Addendum #3

PROJECT: **WASTEWATER TREATMENT PLANT– SLUDGE DEWATERING
INVITATION TO QUOTE**

FILE NO: 2017-001

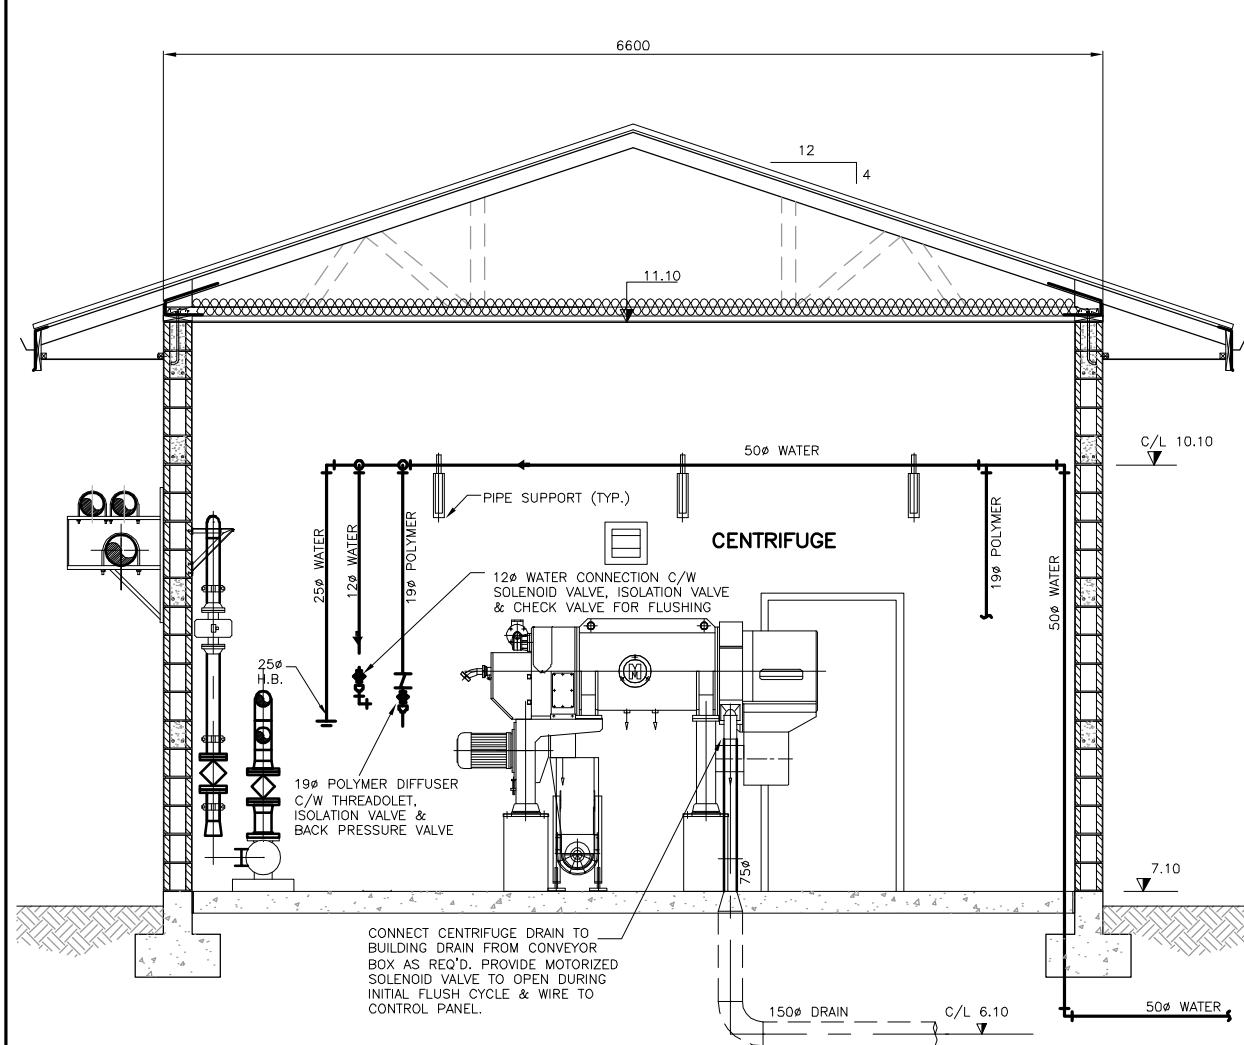
16. Where does the centrate go once it leaves the centrifuge?

The centrate is recirculated by gravity to the headworks.

CLIENT DISTRICT OF SOOKE		DATE DRAWN AUG 2004
TITLE WASTEWATER TREATMENT PLANT GENSET/CENTRIFUGE/BLWR BLDG. SECTIONS		SHEET JOB NO. 1120-60664
REVISION 2 5		DRAWING NO. P602
STATUS NO.

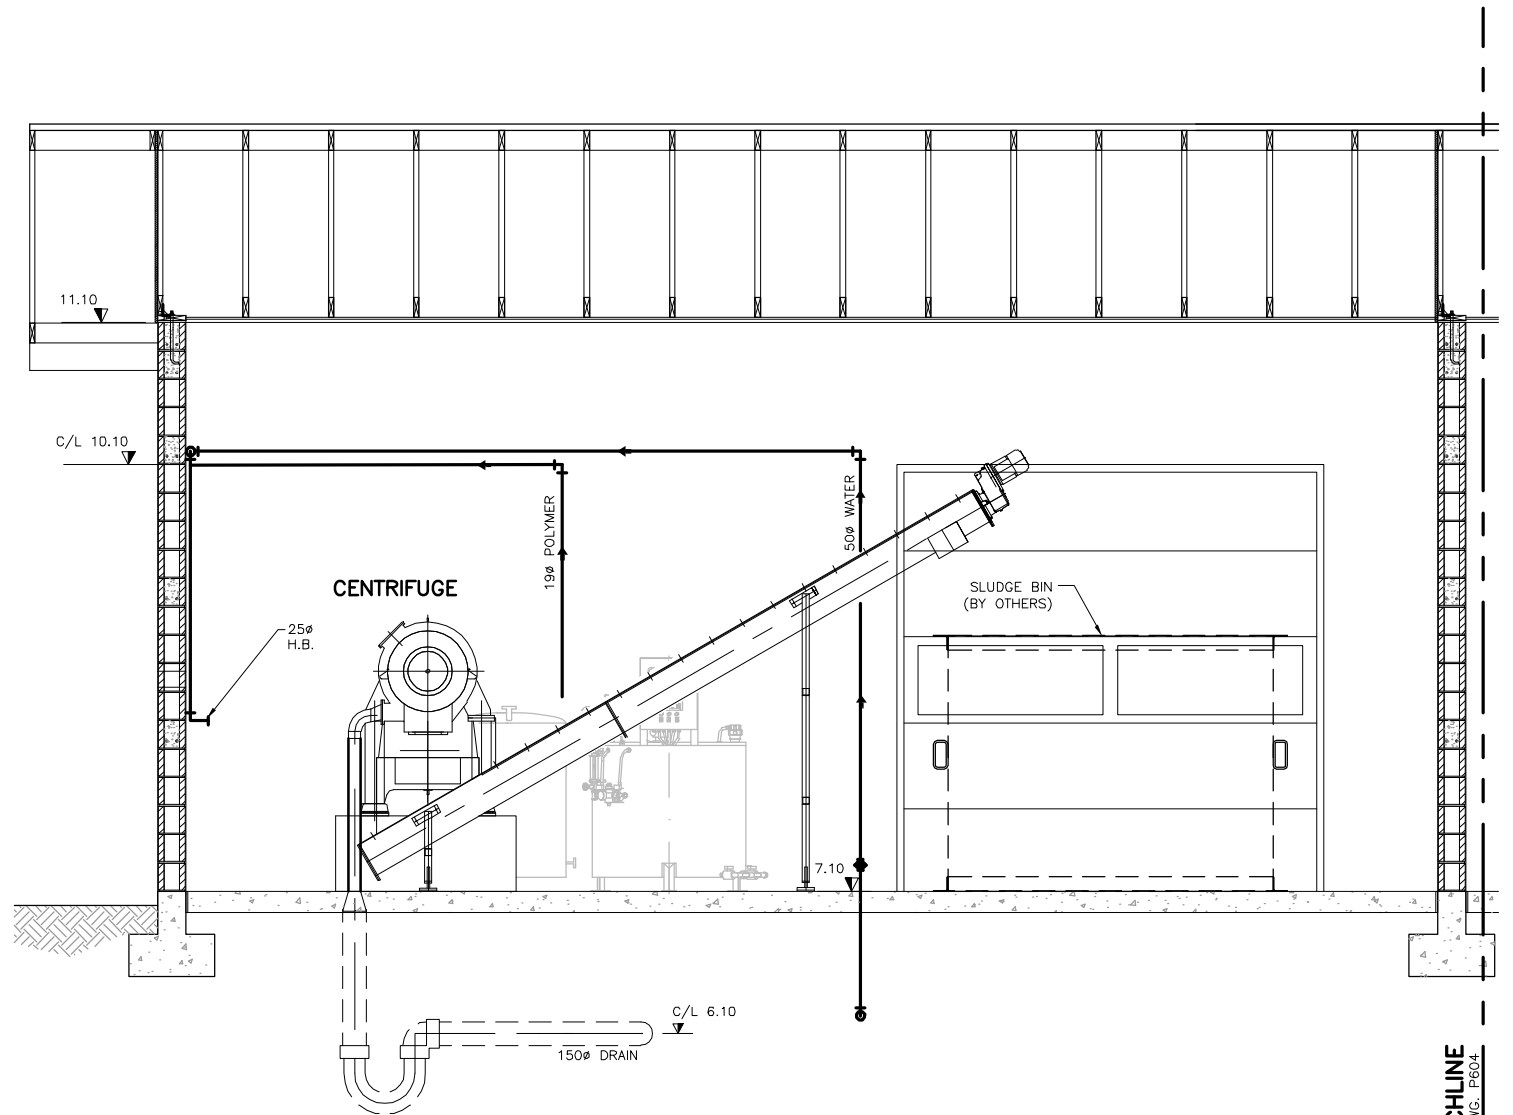
1. **Are you able to provide a drawing, drawn to scale, providing the present layout of all equipment in the centrifuge building?**

Attachment – Centrifuge Building lay-out
